Access Compliance Report

Public Rights-of-Way

Intersection ID: 45733	Main Street: REDWOOD VALLEY LN	Cross Street: DALTREY LN	Location: SW
ADA ID: 8E002FCC83F0	Ramp Type: Perpendicular Diagonal	Initial Pass/Fail: Fail	Overall Compliance: No
		Severity Score: 12.5

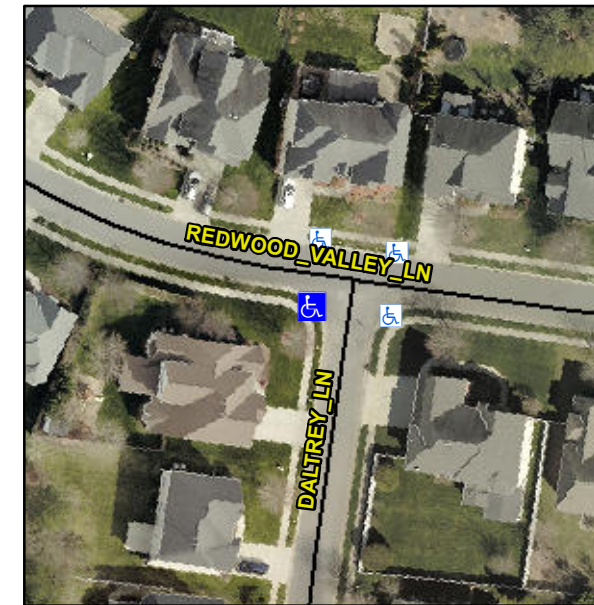
Not Found, R304.2.2

Compliance	Description	Data	Compliance	Description	Data
N/A	Ramp Length (in)	48.0	No	Ramp Slope (%)	8.7
Yes	Ramp Width (in)	48.0	Yes	Ramp XSlope (%)	0.4
N/A	Flare Type LT	N/A	N/A	Flare Type RT	N/A
N/A	Flare Slope LT (%)	N/A	N/A	Flare Slope RT (%)	N/A
N/A	Flare Traversable LT?	N/A	N/A	Flare Traversable RT?	N/A
N/A	Landing Length (in)	N/A	N/A	DWS Provided?	N/A
N/A	Landing Width (in)	N/A	N/A	DWS Contrast?	N/A
N/A	Landing Slope (%)	N/A	N/A	DWS Length (in)	N/A
N/A	Landing X Slope (%)	N/A	N/A	DWS Full Width?	N/A
N/A	Landing Curb? (Y/N)	N/A	N/A	DWS Offset (in)	N/A
N/A	Shared Landing?	N/A			
N/A	Gutter Ponding?	N/A	N/A	Gutter Slope (%)	N/A
N/A	Gutter Lip Ht (in)	N/A	N/A	Gutter X Slope (%)	N/A
N/A	Painted X Walk1?	No	N/A	Painted X Walk2?	No
	X Walk 1 Direction	To SE		X Walk 2 Direction	To NE
N/A	X Walk 1 Width (in)	N/A	N/A	X Walk 2 Width (in)	N/A
	X Walk 1 Slope (%)	0.9		X Walk 2 Slope (%)	0.3
	X Walk 1 X Slope (%)	2.8		X Walk 2 X Slope (%)	0.1

Remove & Replace Curb Ramp With Two New Directional Ramps or Equivalent.
